# EvoBus

TI No.: 32.00U08919A

TITLE: **Frame-end connect : of trailing arms with settlement of adjustment shim**

M32.00-0129-71

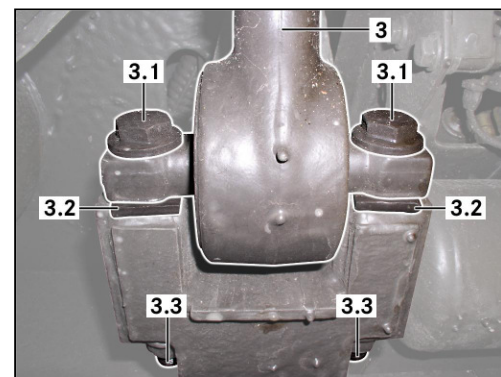
- Remove corros : inhibitor from bolt heads (3.1) and nuts (3.3).
- Retighten nuts (3.3) to the specified torque.

380 Nm

- Recoat screw heads (3.1) and nuts (3.3) with corros : inhibitor.
